# UNITED STATES PATENT AND TRADEMARK OFFICE

APPLICATION NO.	FILING DATE	FIRST NAMED INVENTOR	ATTORNEY DOCKET NO.	CONFIRMATION NO.
10/784,841	02/23/2004	Bruce Allan Crawford	CHANN.P002	1477

<b>Office Action Summary</b>	<b>Application No.</b> 10/784,841	<b>Applicant(s)</b> CRAWFORD, BRUCE ALLAN	
	<b>Examiner</b> D S. Meislin	<b>Art Unit</b> 3723

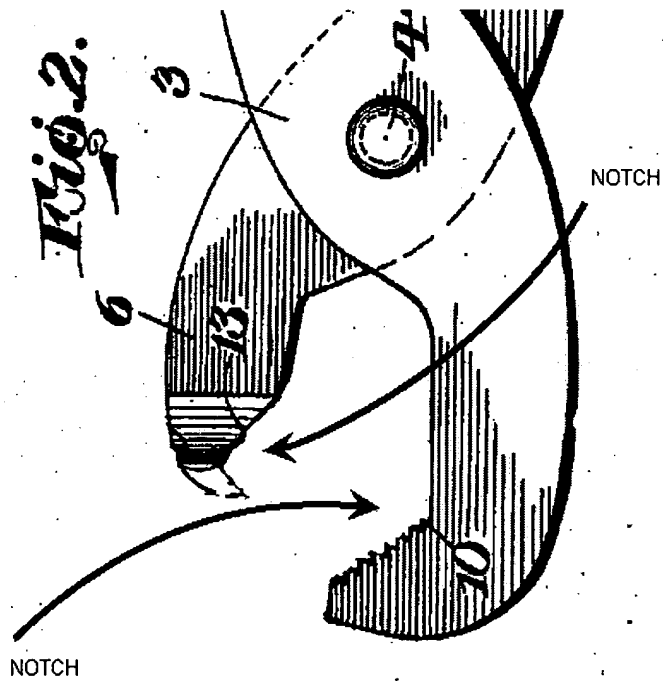
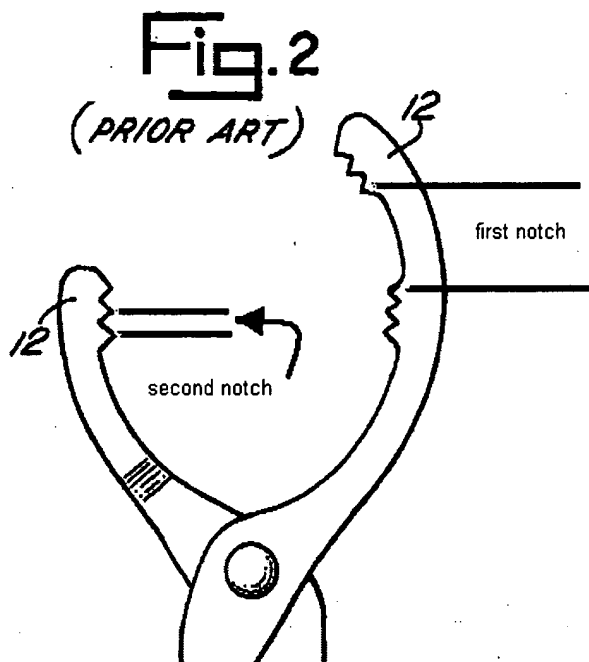
The prior art discloses the claimed notches and walls as broadly claimed by applicant. It is noted that the teeth of the prior art include distally disposed rectilinear walls. Nation and Negus disclose notches as shown below.
